Summary of 50.54(q) Analyses, Cooper Nuclear Station Emergency Plan, Revision 71

Cooper Nuclear Station Emergency Plan, Revision 71

Figure 7.2-3 EOF Floor Plan

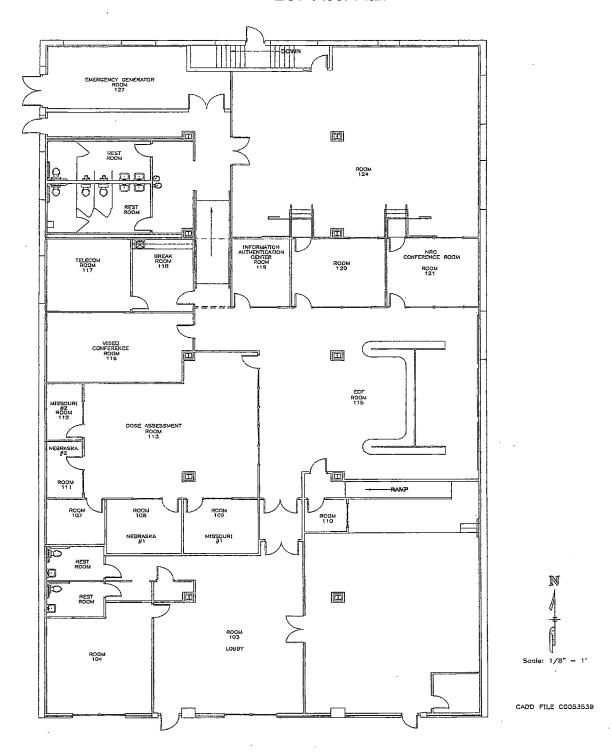
CNS E-Plan, Section 7.2.3, Emergency Operations Facility (EOF), was revised to remove the Nebraska Emergency Management Agency (NEMA) mobile operations trailer (MOT) as being a potential vehicle stationed adjacent to the EOF. NEMA has replaced the MOT, which was a pull-behind converted camper, with a mobile operations center (MOC). The MOCs are converted recreational vehicles which are refitted with communications packages and power generation.

CNS E-Plan, Section 7.2.3, discusses that NEMA's MOC or MOT and the Nebraska State Patrol mobile command post may be stationed adjacent to the EOF. The section also describes the vehicles as self-sustaining with their own electrical power and communications systems.

Replacement of the MOT to an MOC is considered an equipment upgrade. The MOC maintains the same capabilities and methods as the MOT previously being used. As such, the change does not constitute a reduction in the effectiveness of the CNS E-Plan.
